Technical Bulletin

RVU - Rain Sensor, Installing (OT)

00 06 11 Oct. 18, 2006 2013193

Model(s)	Year	Eng. Code	Trans. Code	VIN Range From	VIN Range To
Touareg (US only)	2007	All	All	7L_7D000001	7L_7D034999

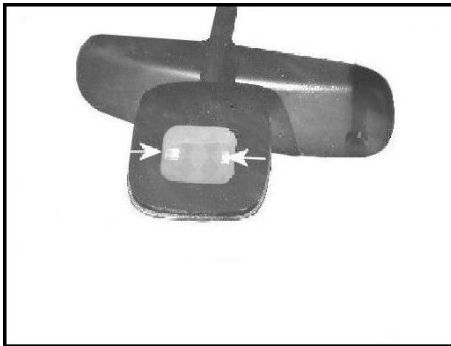
Intermittent Wiper Mode May Function Erratically on Vehicles With Rain Sensor, Wiper Intermittent Function Delay Time Does Not Change When Dial is Changed. This condition may be present on early production rain sensors.

Improved Rain Sensor as of VIN: 7L_7D035000.

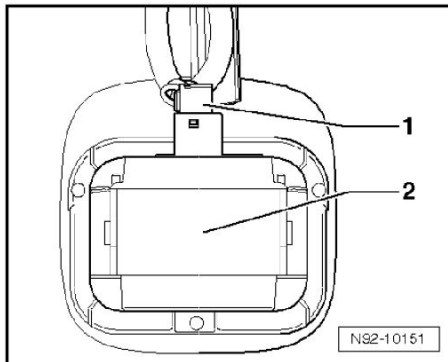
- Identify rain sensor 1K0955559R/T (there is only one set of diodes in the center of the part that contacts the windshield).

- Install improved rain sensor Part No: 1K0955559AB.

The improved rain sensor is identifiable by the white optical receptors - arrows-, or if viewed closely, the stacked diamond shape through the middle of the sensor.
